PLANNING COMMISSION AGENDA  
CITY OF PRAIRIE VILLAGE  
MUNICIPAL BUILDING - 7700 MISSION ROAD  
TUESDAY, SEPTEMBER 6, 2011  
Multi-Purpose Room  
7:00 P.M.

## STAFF REPORT

**Application:** PC 2011-115

**Request:** Site Plan Approval for Phase 2 Corinth Square North

Corinth Square Retail Center  
 Site Improvements - Phase II  
 Site Layout Plan  
 Somerset Drive & Mission Road  
 Prairie Village, Kansas

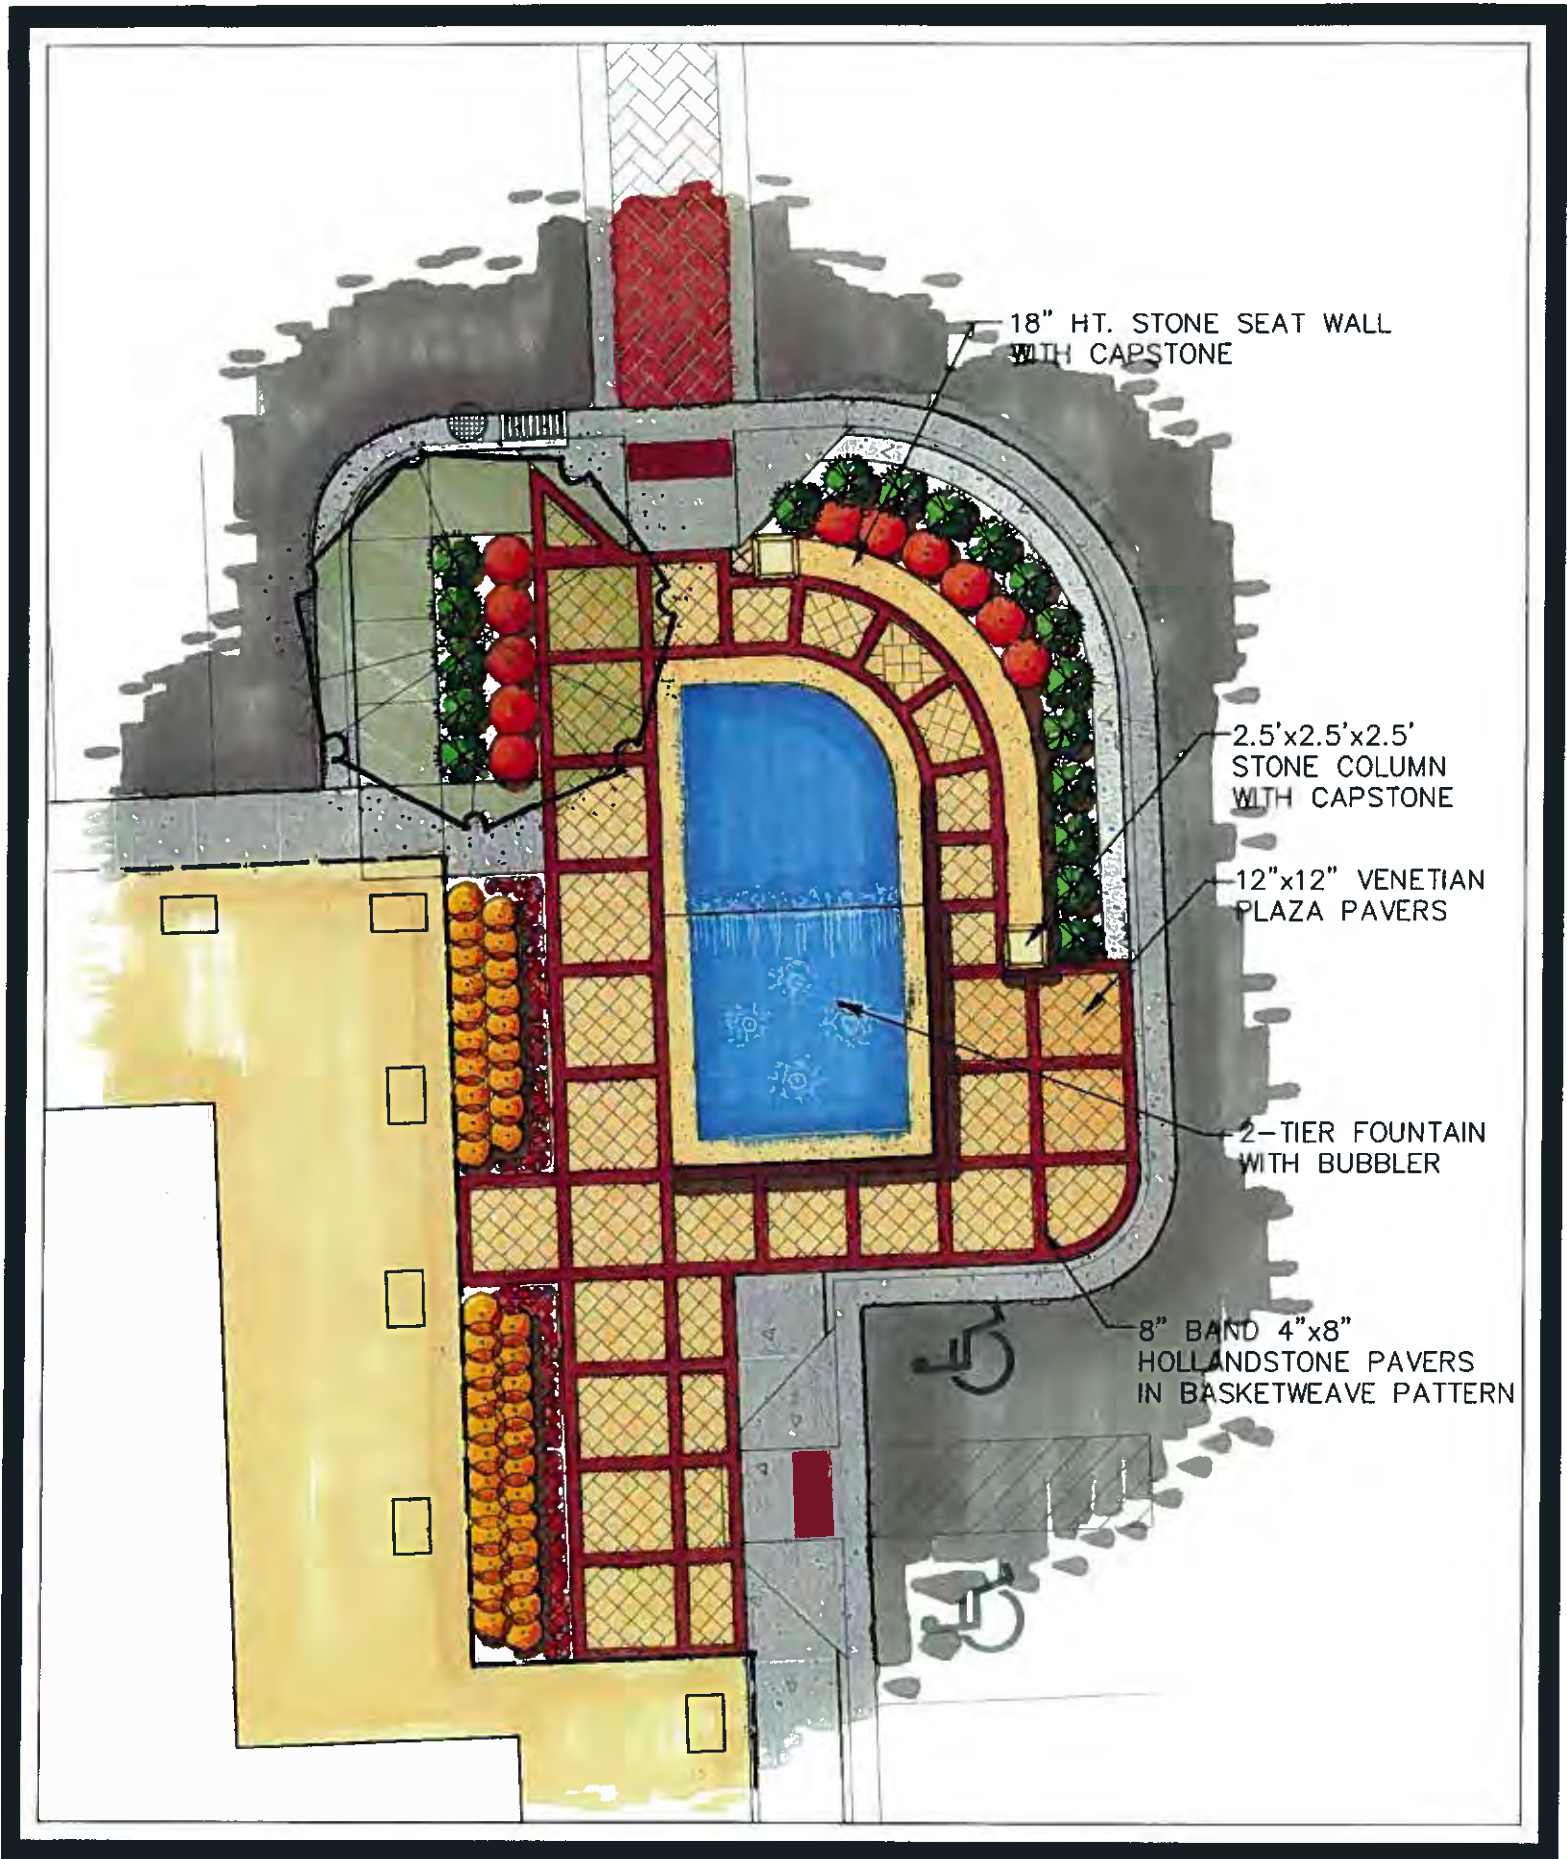
It was anticipated that more landscaping would be included to break up the hard surface between the parking spaces and the buildings. There is only one landscape bed on the east, west and south sides of the core building. Consideration should be given to providing more greenspace between the buildings and the parking.

In the parking area east of Hen House ornamental trees are proposed in the north and south ends of the lot. Additional trees should be provided in the middle. Ornamental trees will not provide much canopy and it would be preferable to select shade trees for the parking lot islands that provide more canopy and shade. The same comments apply to the parking area west of Commerce Bank.

The changes in parking layout and circulation in Phase I and the addition of landscape islands and pedestrian walkways may have changed the number of parking spaces that are now available. The applicant needs to update the parking count and leasable area to verify that parking requirements are still being met. This information should be added to the site plan drawings.

Previous efforts to grow trees in the parking areas has had limited success primarily because they could not be watered. An irrigation system needs to be installed in order to properly maintain the proposed landscape improvements.

- 1) That the applicant select shade trees rather than ornamentals for the parking area islands.
- 2) That the revised landscape plan be submitted to the Tree Board for review and Staff approval prior to installation and an irrigation system be installed to provide water for all landscape improvements.

- 3) That the applicant include additional trees in the parking areas between Hen House and the core building and in the parking area on the south west of Commerce Bank.

- 4) That the applicant give more consideration to providing additional landscape beds on the east, west and south sides of the core building.
- 5) That the applicant submit cut sheets for the fixtures for area and building lighting to Staff for review and approval.

- 8) That the applicant provide an updated parking count and summary of leasable area and include the information on the site plan drawings.
- 9) That the applicant revise all drawings based on revised submittals the conditions approved by the Planning Commission and submit three copies of the final drawings to Staff prior to obtaining a building permit.
